Re: Response to Comments -- Permit Modification Request with Notice  
Monitoring Well Installation and Abandonment  
Addicks-Fairbanks Landfill  
USA Waste of Texas Landfills, Inc.  
Harris County, Texas  
TCEQ Permit No. MSW-1301  
Tracking No. 12911350

**NOTICE OF DEFICIENCY LETTER DATED JANUARY 8, 2010  
FROM ELIZABETH SLONE – WASTE PERMITS DIVISION  
MUNICIPAL SOLID WASTE LANDFILL – HARRIS COUNTY  
ADDICKS-FAIRBANKS LANDFILL, PERMIT NO. MSW 1301  
PERMIT MODIFICATION-MONITOR WELL INSTALLATION AND ABANDONMENT-  
NOTICE OF DEFICIENCY (NOD)  
TRACKING NO. 12911350; RN101519569/CN602560930**

| <b>A15-1</b>               |                    |                           |  |

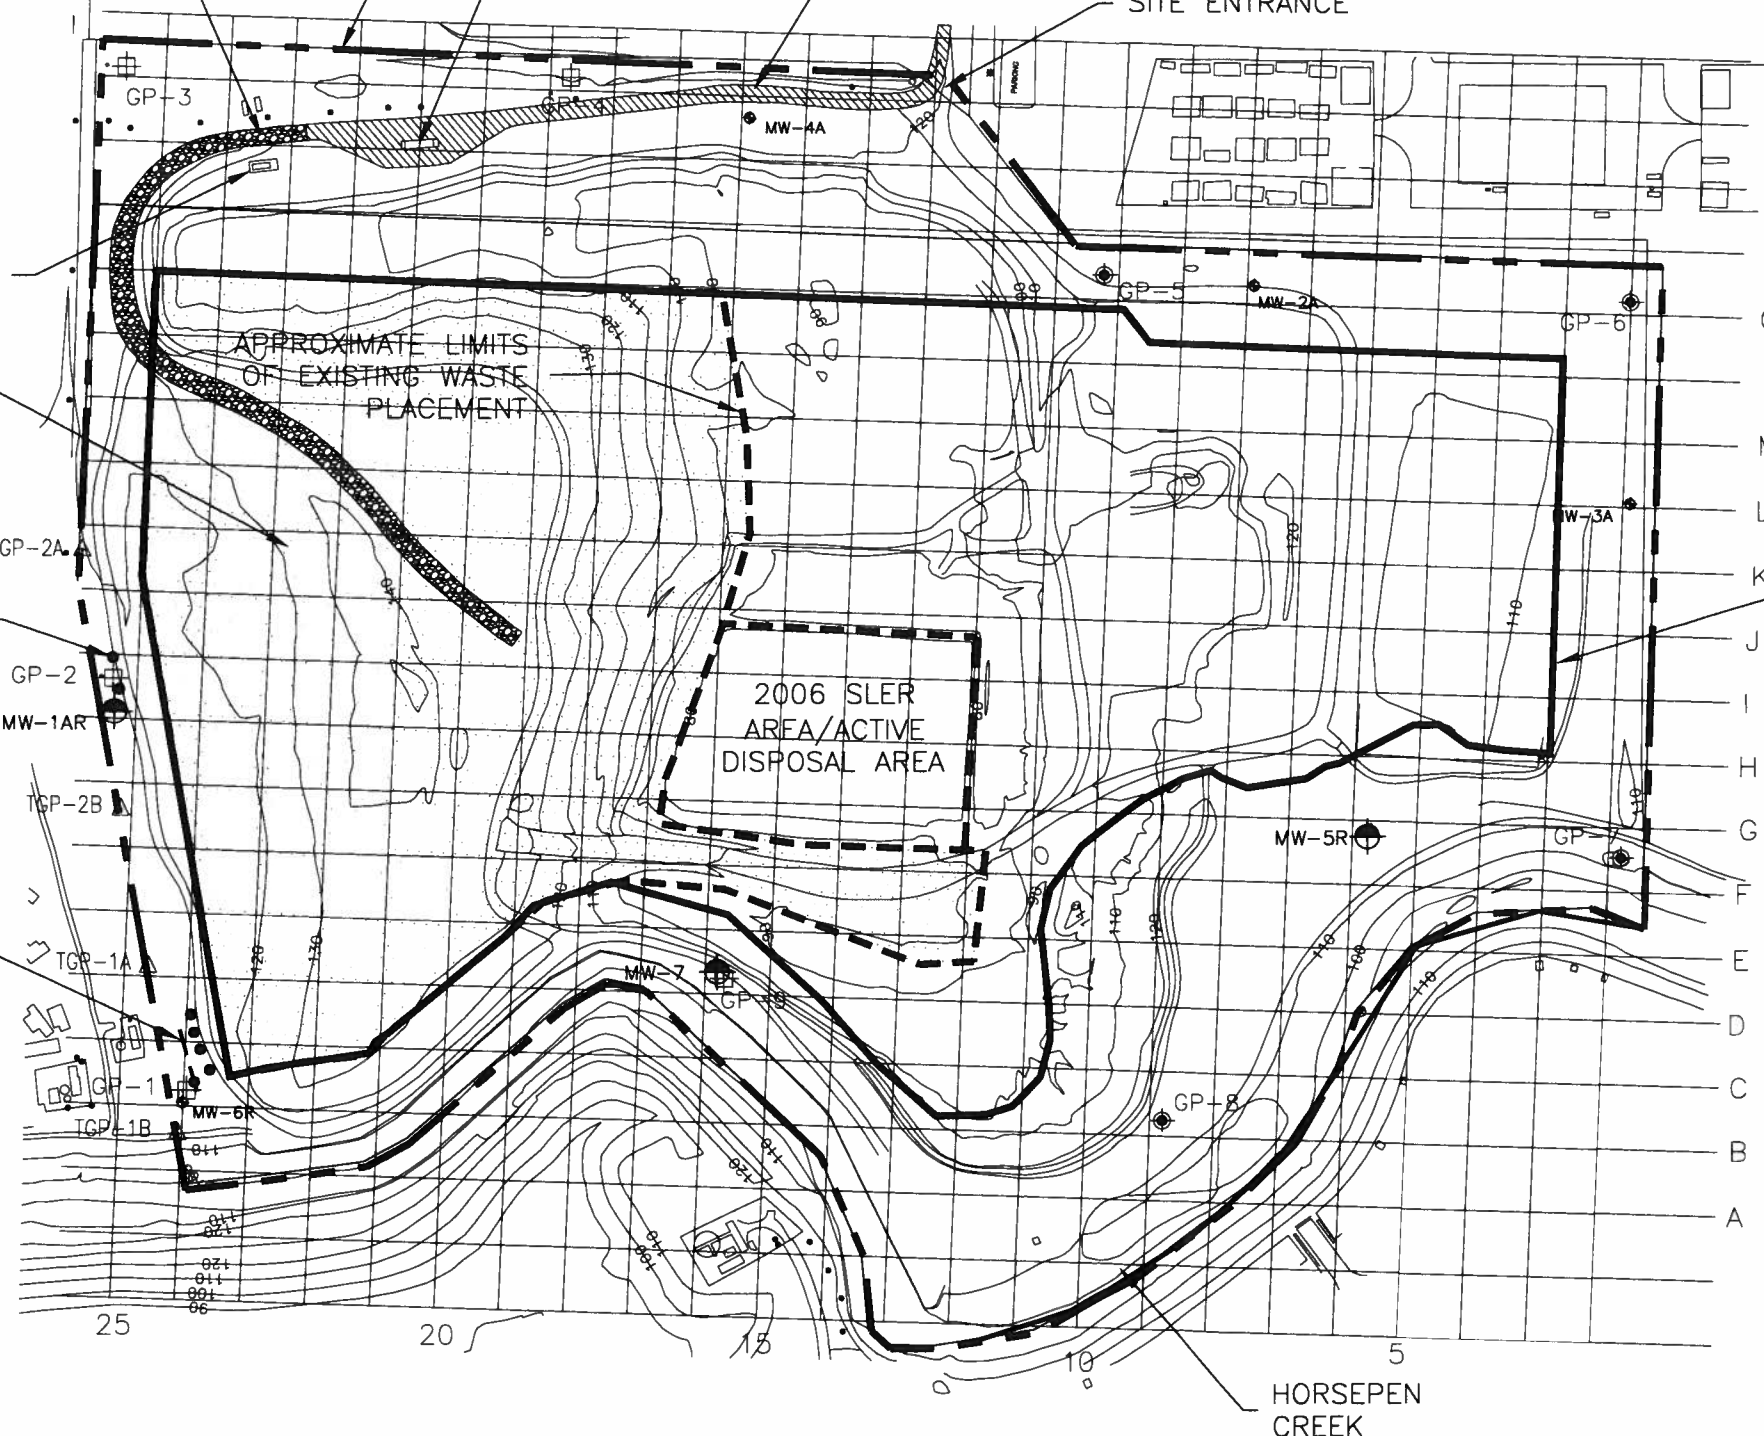
**Comment 2. Figure A15-1, Monitor Well Location Map**

- a. **Please revise the clean copy of Figure A15-1 to remove the two monitoring wells, MW-1A and MW-5, which are to be plugged and abandoned.**
- b. **In the permit modification narrative, it states that the replacement monitoring well for MW-1A will be designated MW-1AR. However, on Figure A15-1 the replacement monitoring well is labeled MW-1 R. Please revise as appropriate.**

Response 2. Figure A15-1 has been revised to delete the monitoring wells which are proposed to be plugged and abandoned, and the replacement monitor well has been revised to be labeled MW-1AR. A replacement Figure A15-1 is included with this response to comments.
